BUREAU OF PLANNING AND ZONING

RE: **(24-001 Sketch Plan Review) – 24030006 – 312 HANOVER STREET – SKETCH PLAN REVIEW – Ward 10, Zoned RT, plans dated March 12, 2024.**

Additional Comments Related to the Overall Land Development

WARD
10
BLOCK
3
A

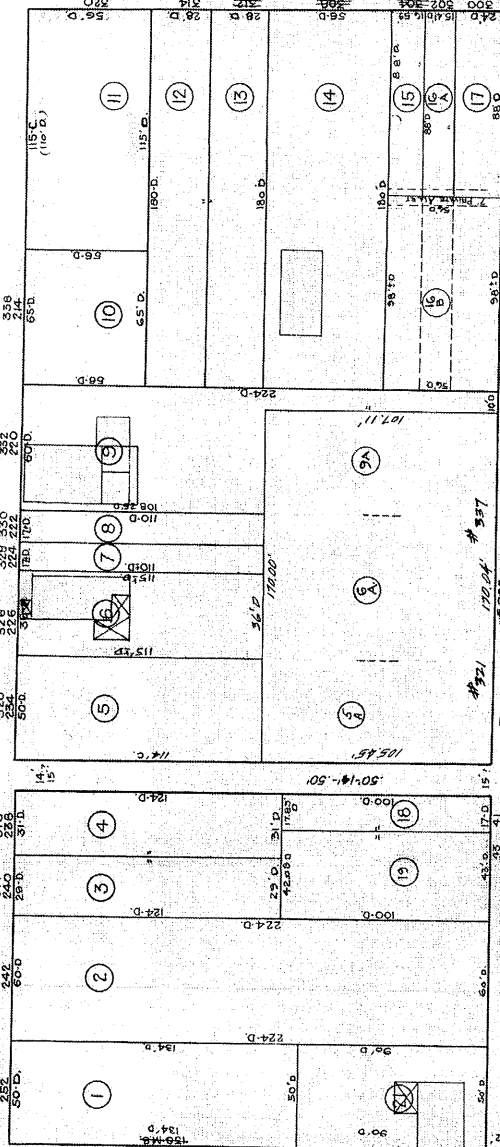
6. Rausch Street adjacent to the subject parcel is 12' in width, Ref. City of Bethlehem Map, Ward 10, Block 3A-attached. The Applicant shall prove to the satisfaction of the City Engineer that vehicle turning movements can be reasonably accommodated between Rausch Street and the proposed parking lot; see also comments from the Office of the Fire Marshall. The Applicant shall install all traffic

controls necessary to allow for the safe passage of vehicles along Rausch Street between Filbert Street and Spring Street.
